THE MARYLAND-NATIONAL CAPITAL PARK AND PLANNING COMMISSION

**MEMORANDUM**

**REVIEW TYPE:** Site Plan

**APPLYING FOR:** 27,272 sf Office Space Emergency Health Care Facility  
**PROJECT NAME:** Germantown Professional Building  
**CASE #:** 8-02010B  
**REVIEW BASIS:** Site Plan Review required in the C-T zone

## **PROJECT DESCRIPTION: Proposal**

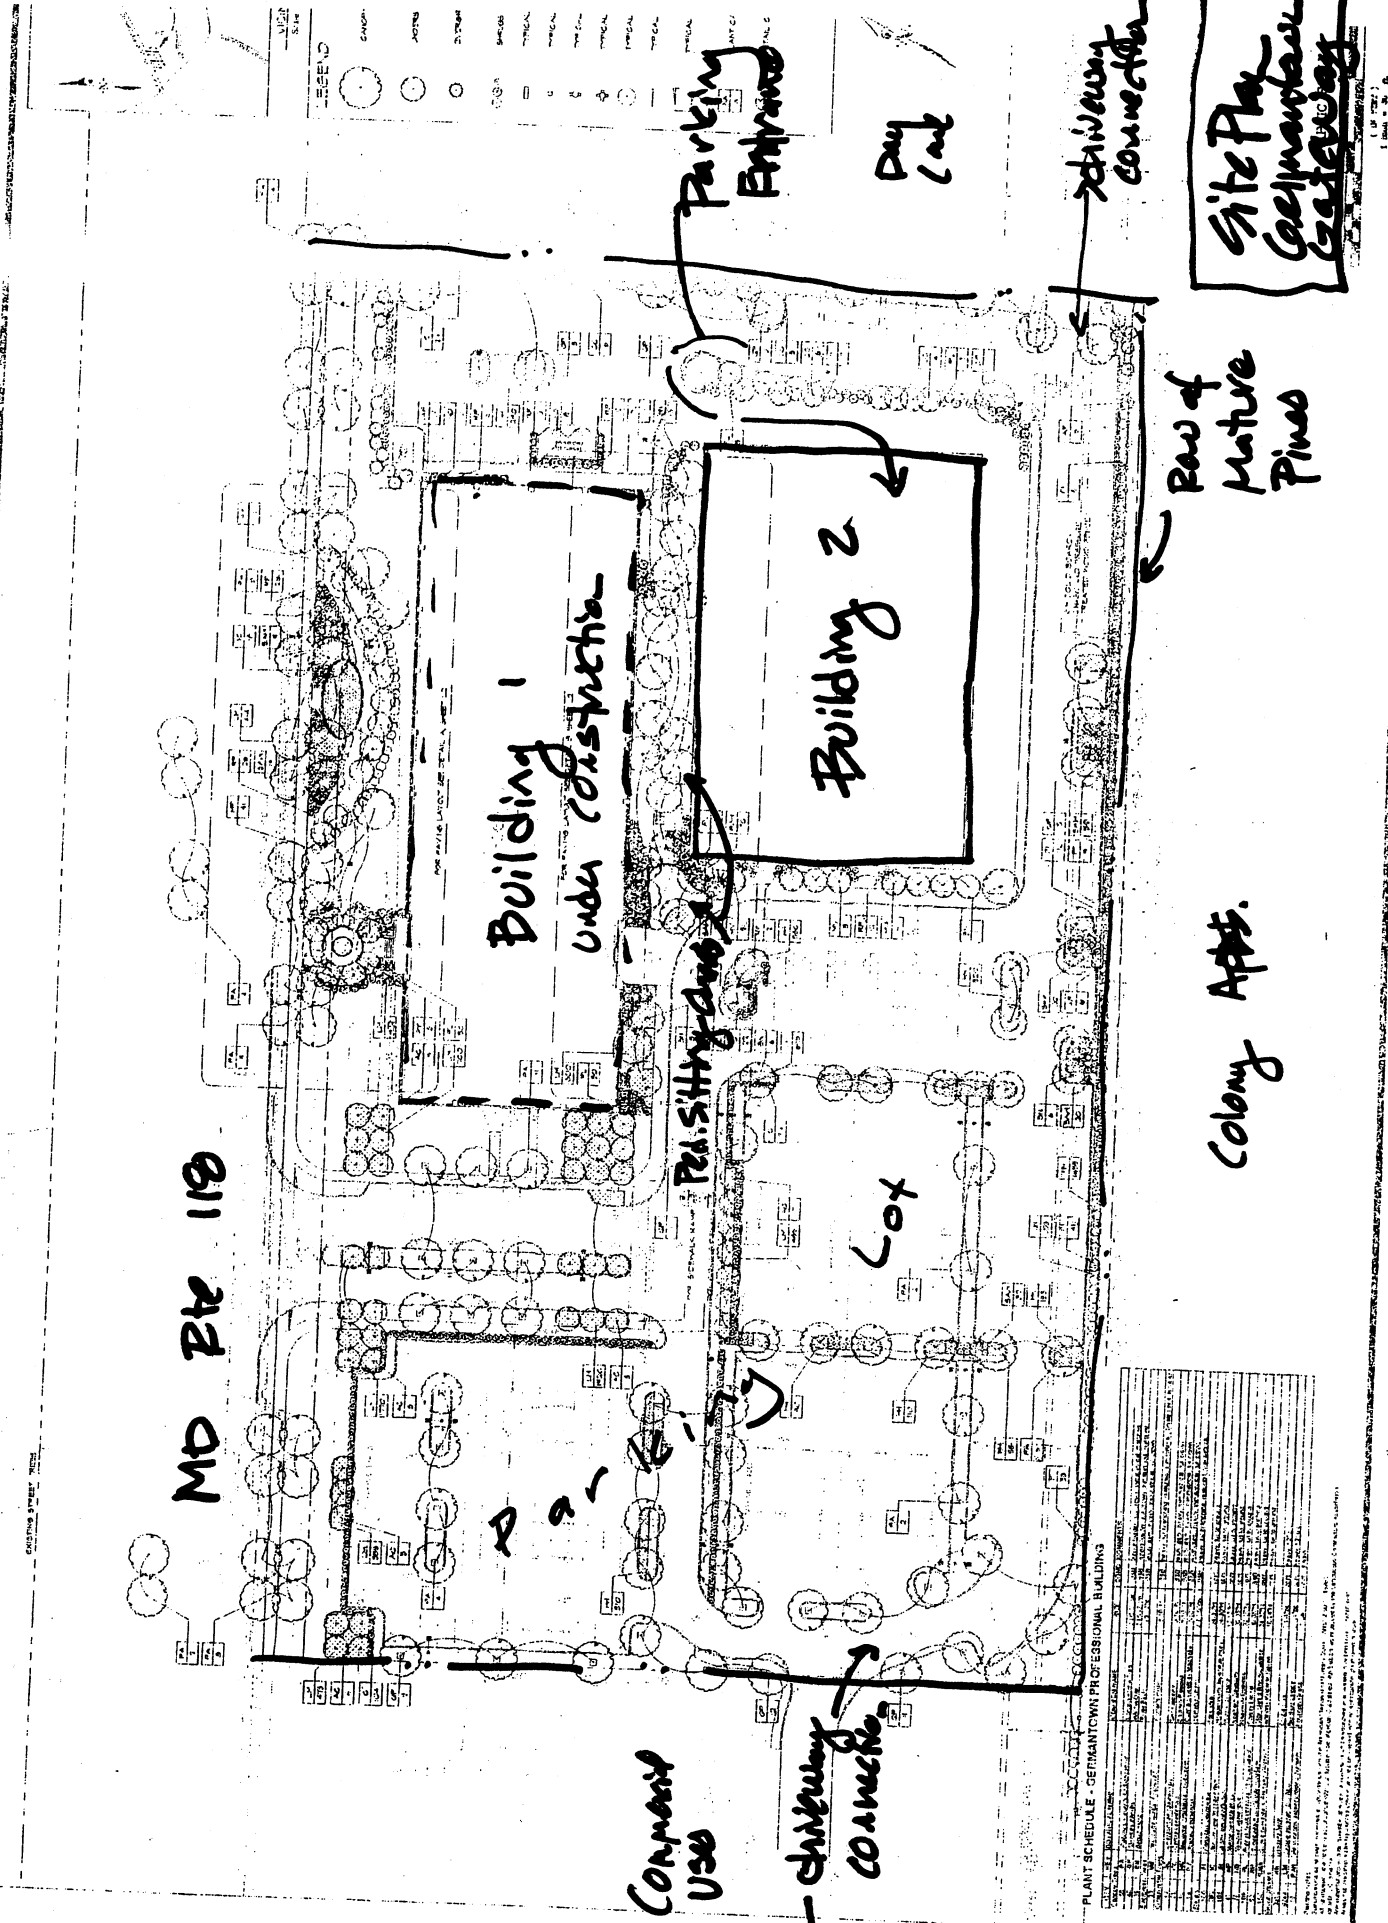
The proposal features a 24 - hour emergency health care facility, the second building on the site following the approval and construction of an office building along MD Route 118. The building is one level – 15 ft – with a one level parking garage below the facility. A 2.5 – 4 foot retaining wall is located on the southern boundary adjacent the apartments. The applicant needs to submit a subsurface parking layout for staff review prior to signature set.

A full pedestrian system – sidewalks, crosswalks and paths - is integrated through the site's parking lot with connections to adjacent parcels to the east and west and to the streetscape along MD Route 118. An additional connection is needed to connect to the east.
